Middleby Marshall *Service Bulletin*

Orientation and part numbers of PS555/570/570S blower wheels and cooling fans - REVISED

PS555/570/570S Blower Wheel Configuration

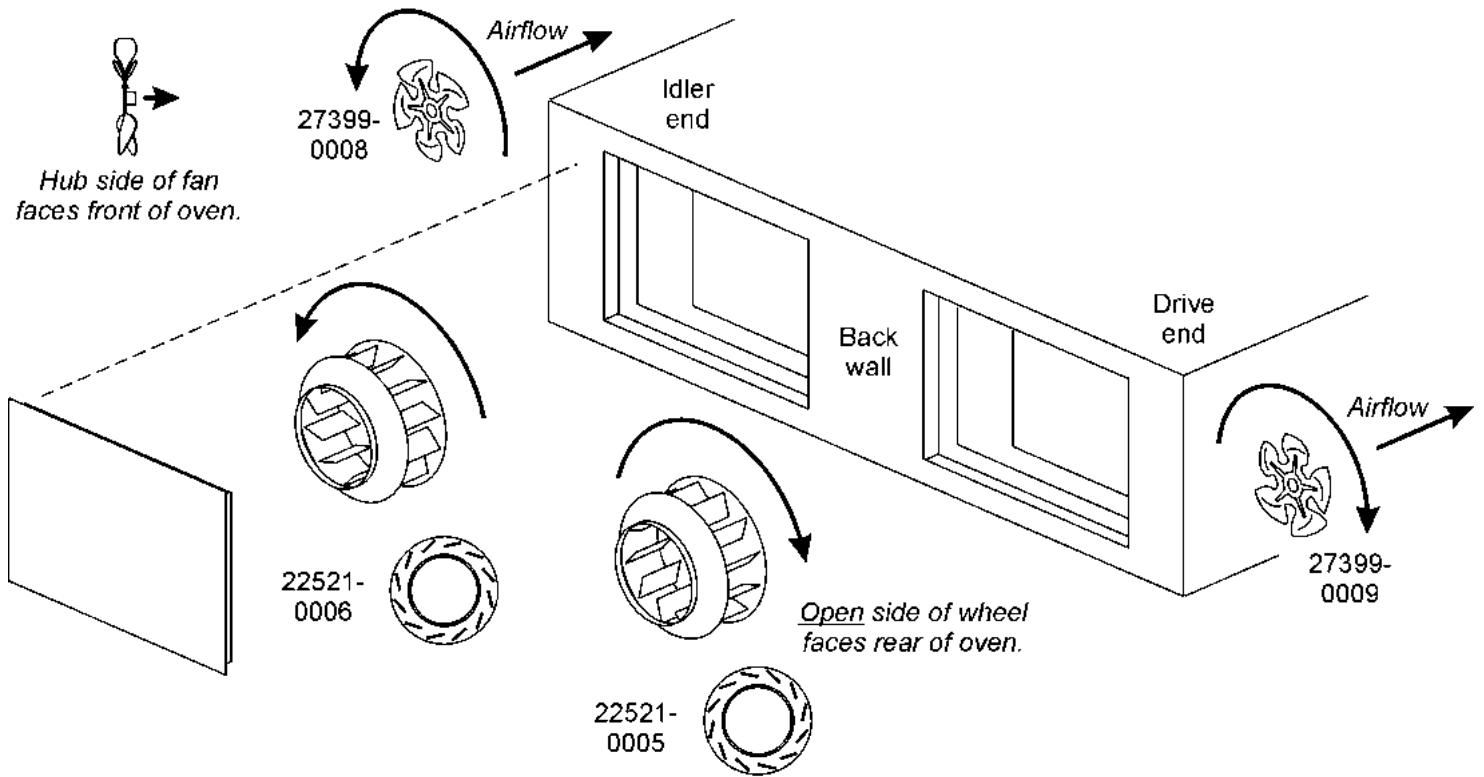
Service Bulletin MM-183, dated 4/23/01, incorrectly identified the part numbers of the blower wheels on PS570 and PS570S ovens. The illustration included with the bulletin correctly showed the fan blade orientation, and the positioning of the wheels inside the oven; however, the part numbers of the two wheels were reversed.

Also, note that the blower wheels and cooling fans for the PS555 oven are IDENTICAL to those used on current-production PS570S ovens. So, the revised illustration included with this Service Bulletin applies to the PS555 as well.

Please DESTROY the illustration that was FAXed with Service Bulletin MM-183.

Refer to the revised illustration on Page 2 of this Bulletin. File a copy of this new illustration with your PS570/570S Parts Manual and your PS555 Parts Manual. Refer to the illustration when ordering blower wheels or cooling fans for these ovens.
